CITY OF PETALUMA

ADDENDUM NO. 2

ELLIS CREEK CHEMICAL SYSTEM UPGRADE PROJECT PHASE I C66501840

July 3, 2024

SODIUM HYPOCHLORITE SYSTEM REPLACEMENT AND RELOCATION ELECTRICAL SINGLE-LINE DIAGRAMS

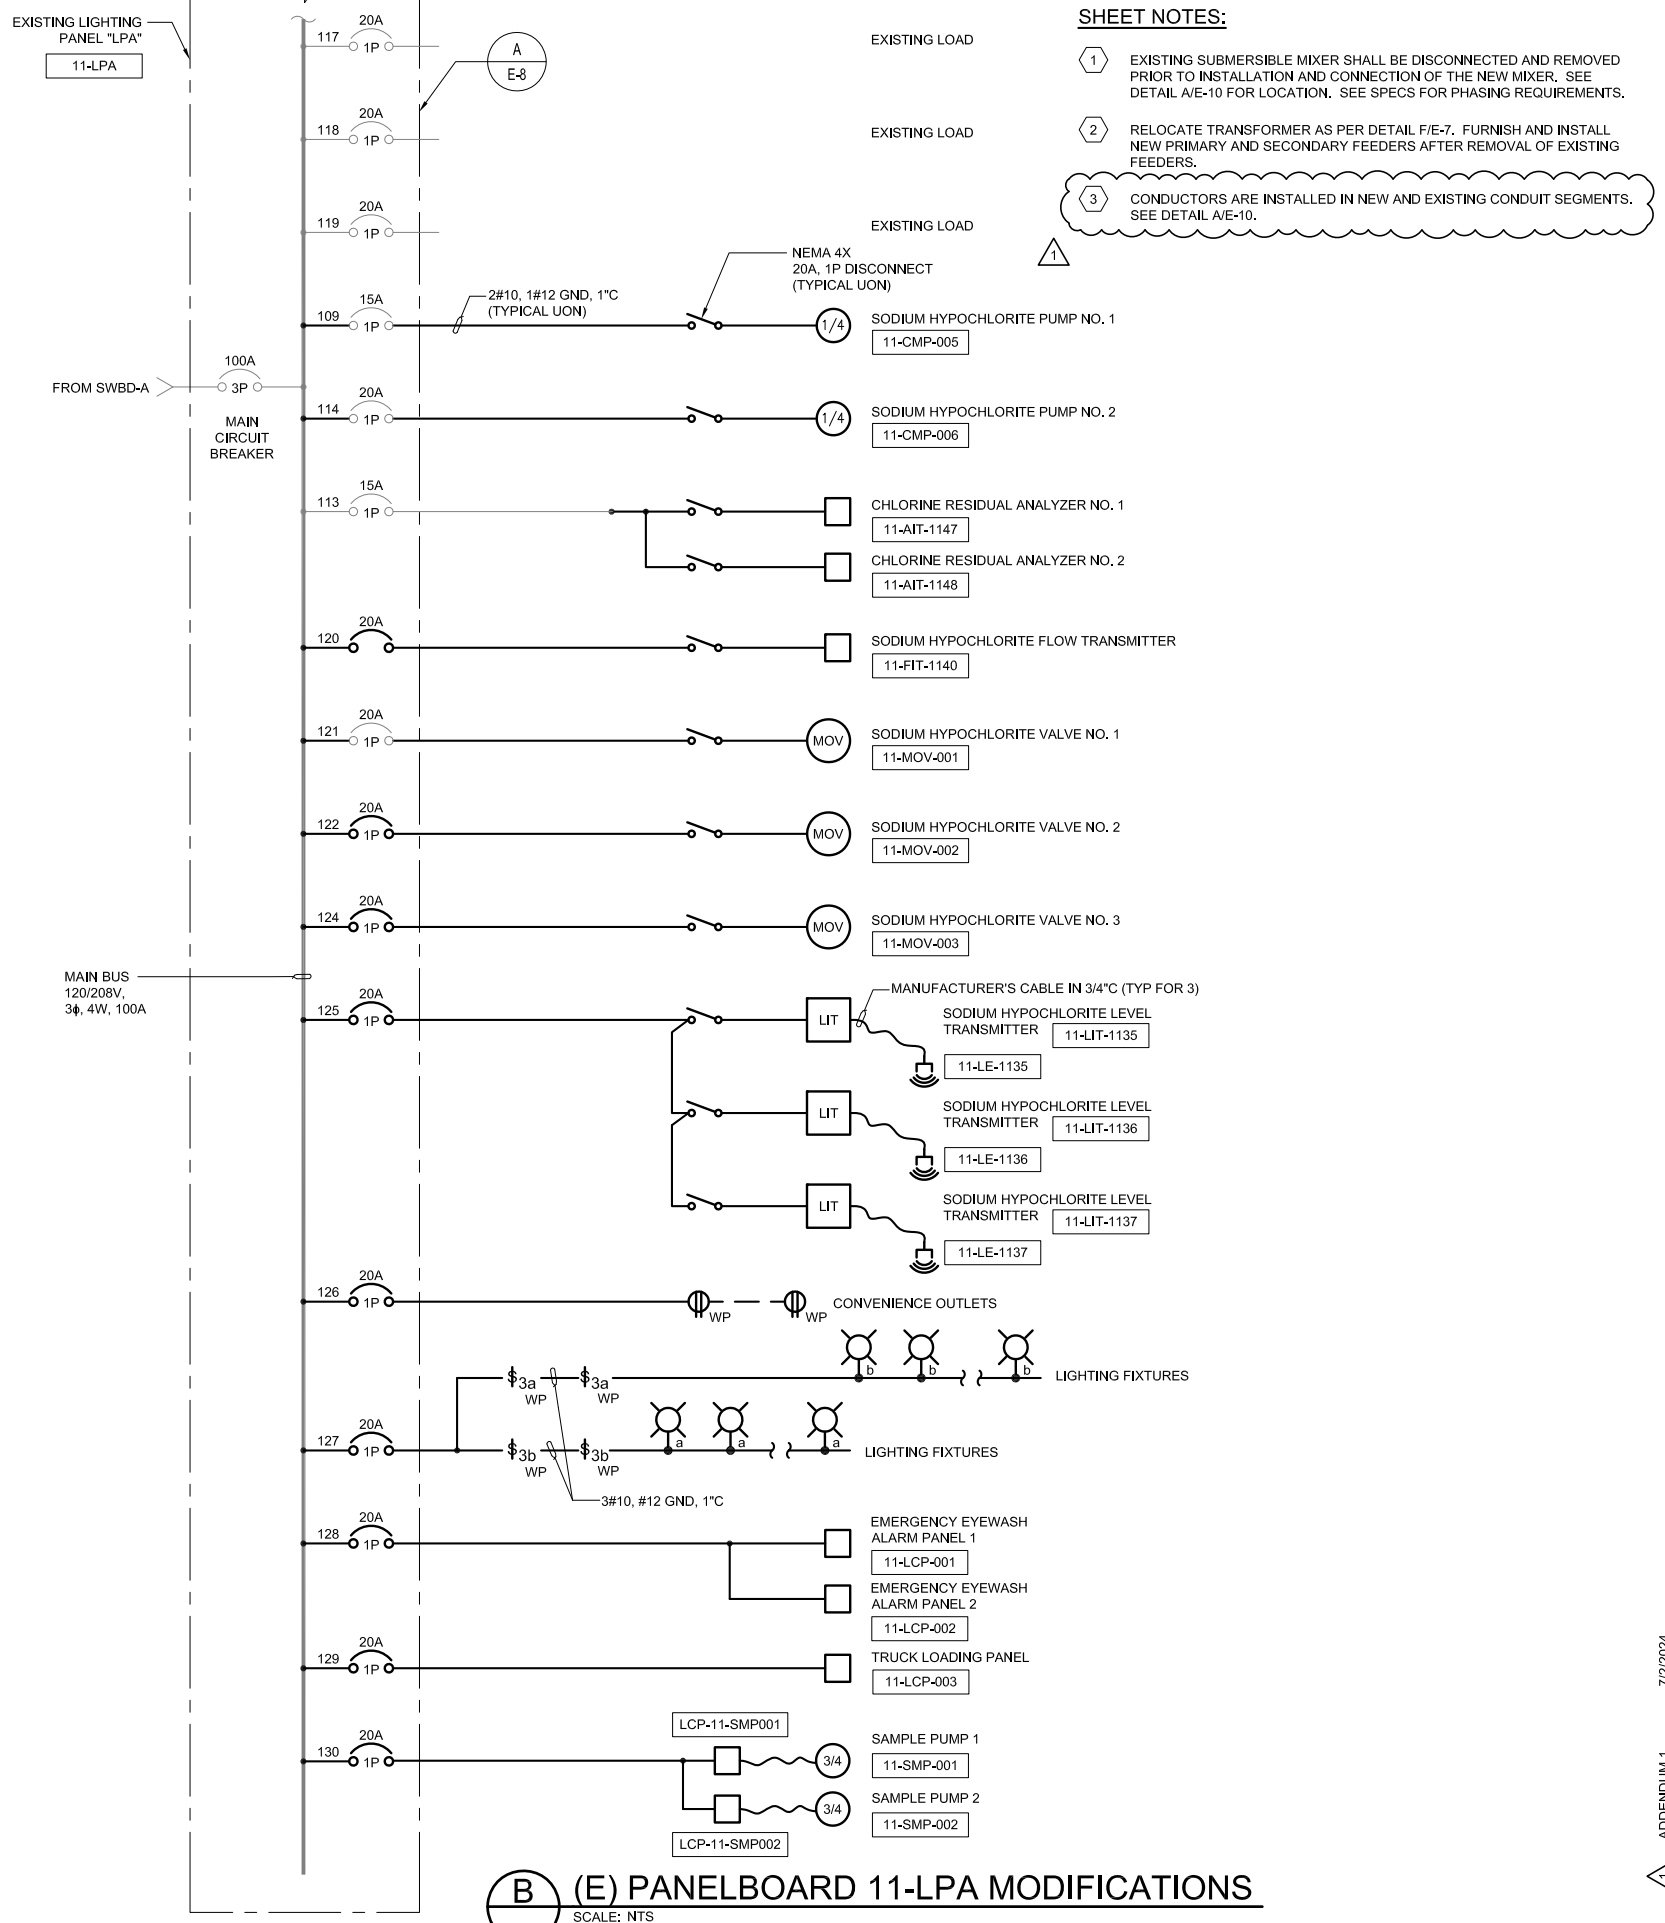
1. Sheet E-2: See attached for clouded items indicating change.
2. Sheet E-10: See attached for clouded items indicating change.
